Subject: Braidwood Station Unit 1
NRC Docket Number: 50-456

Response to Request for Additional Information Pertaining to Operating Interval
Between Eddy Current Inspections for Circumferential Indications in the
Braidwood Unit 1 Steam Generators

ATTACHMENT A
REQUEST FOR ADDITIONAL INFORMATION
RELATED TO THE BRAIDWOOD, UNIT 1 CYCLE LENGTH ASSESSMENT
BASED ON STEAM GENERATOR (SG) TUBE
CIRCUMFERENTIAL INDICATION GROWTH RATES
DOCKET NUMBER 50-456

Figure 10a

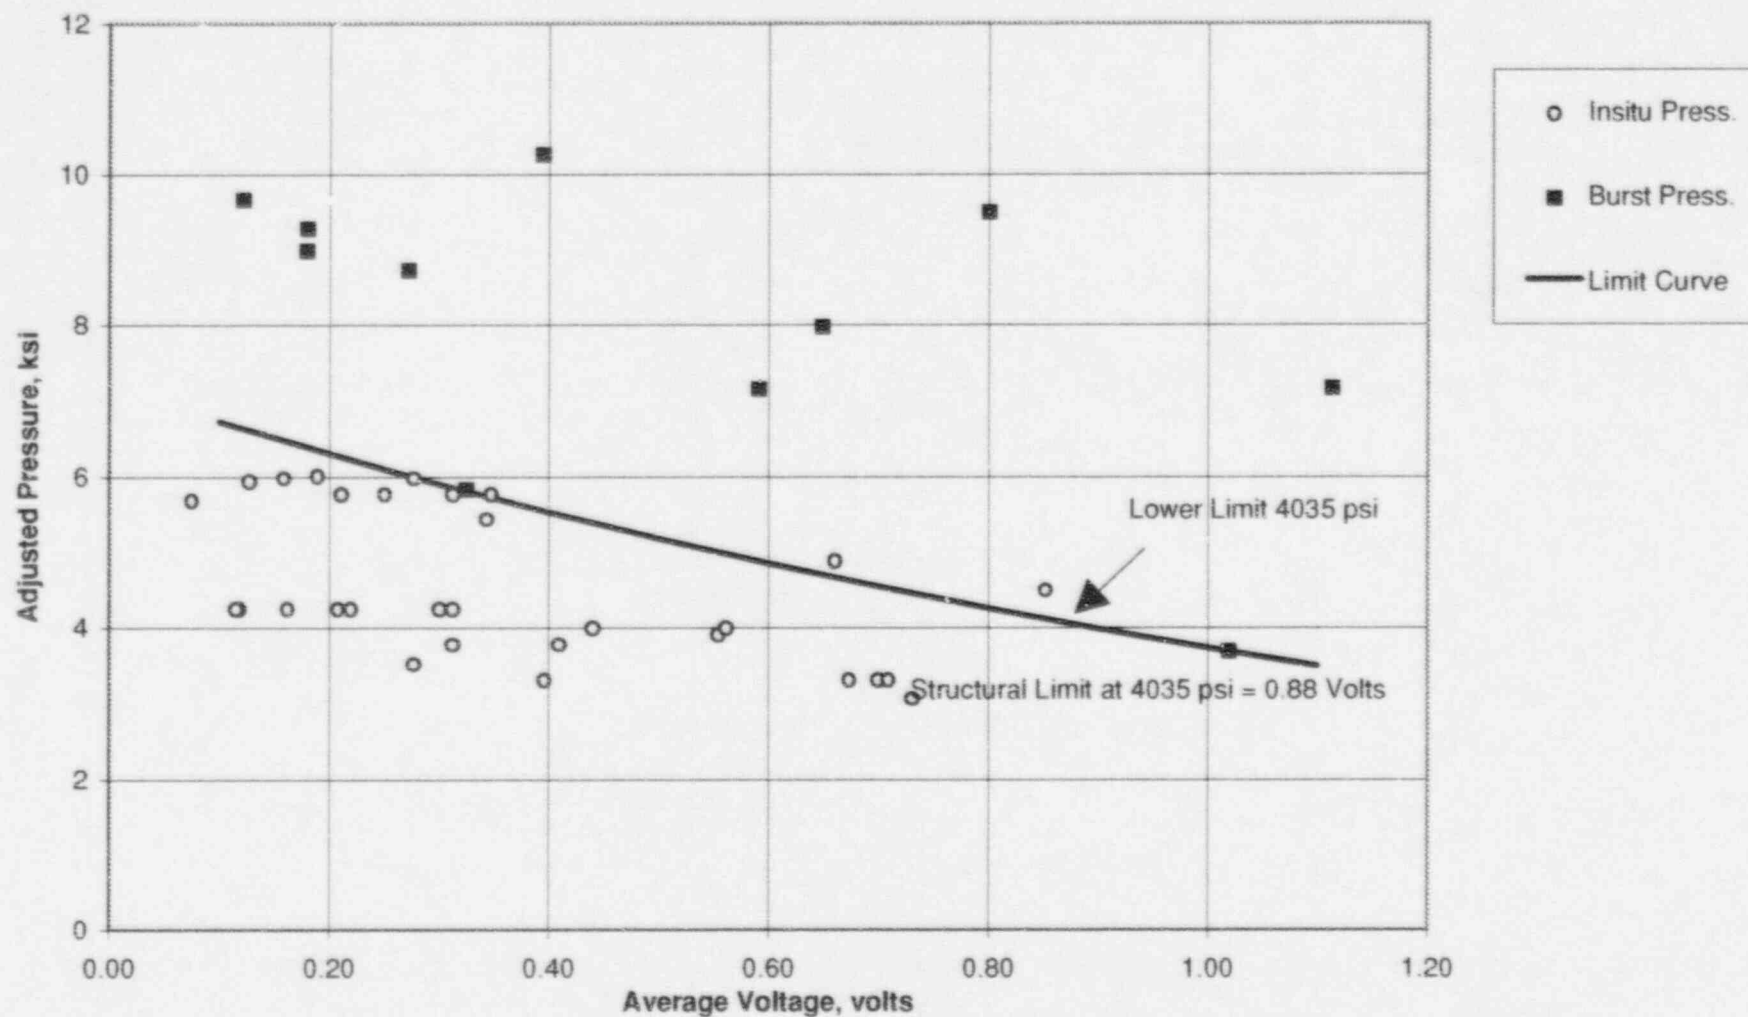
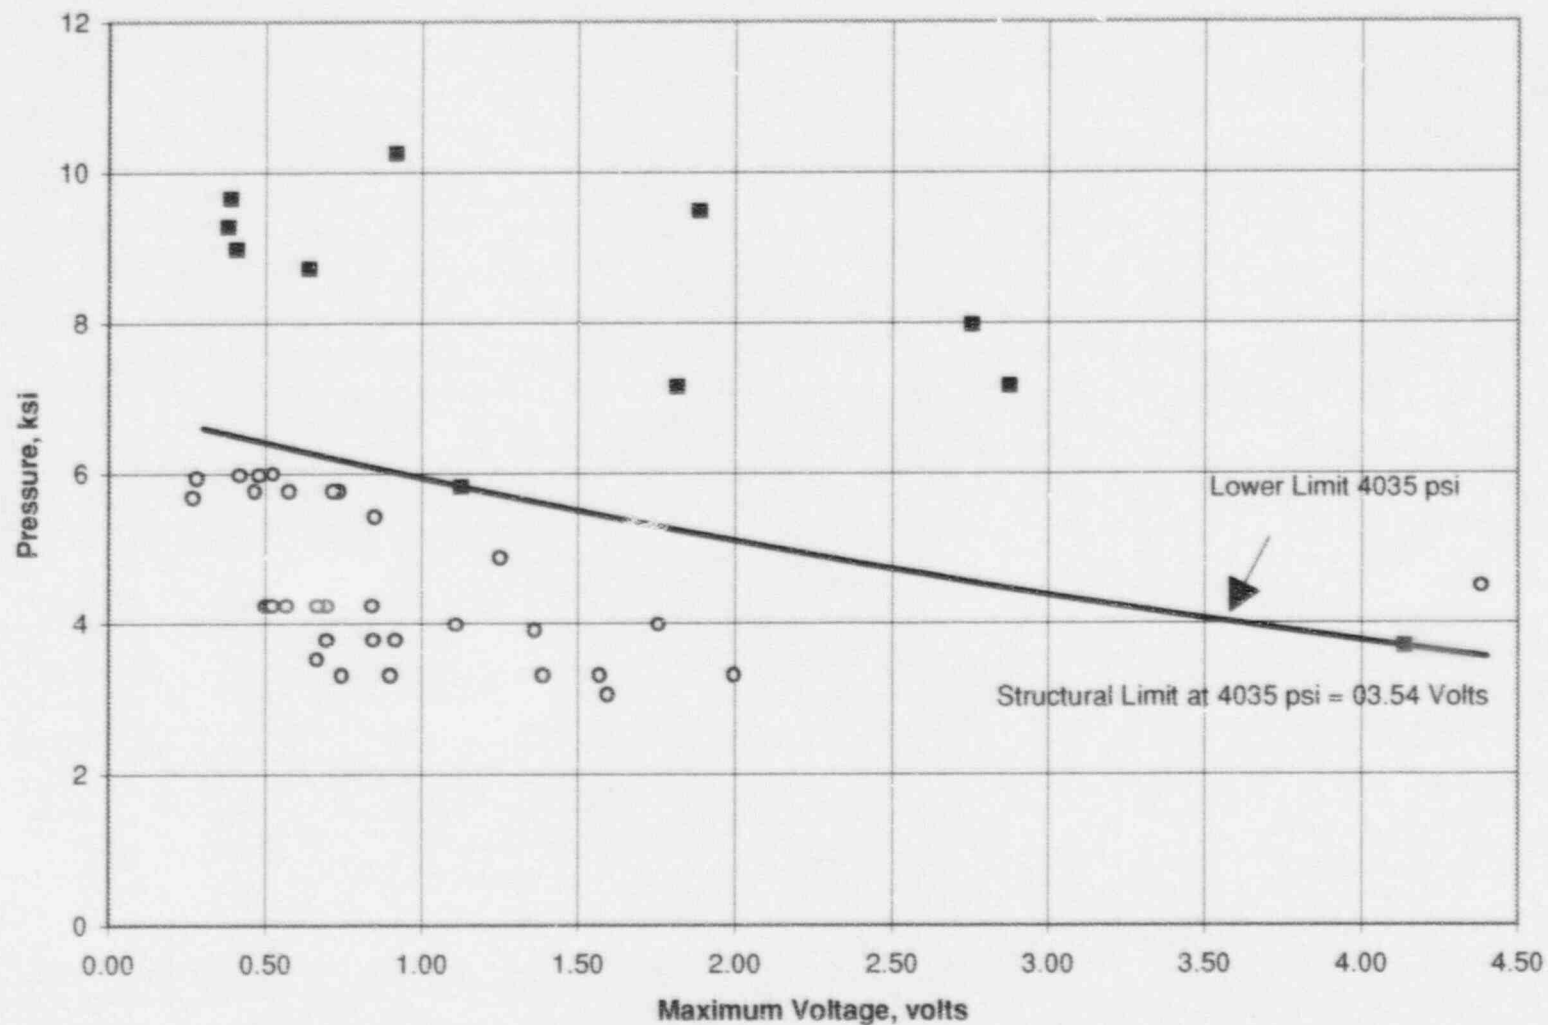
3. Incorrect voltages for one insitu pressure test point were presented on Figures 10a and 10b of the September 10, 1996, submittal. The voltages presented were 0.88 max and 0.63 average volts at a corrected pressure of 3.577 ksi. The voltage data were originally analyzed as 0.080" RPC and no correction applied. Further review of the data identified that the data was acquired with the 0.115" RPC and a correction factor was applied. This data point does not change the results or conclusions of the submittal.
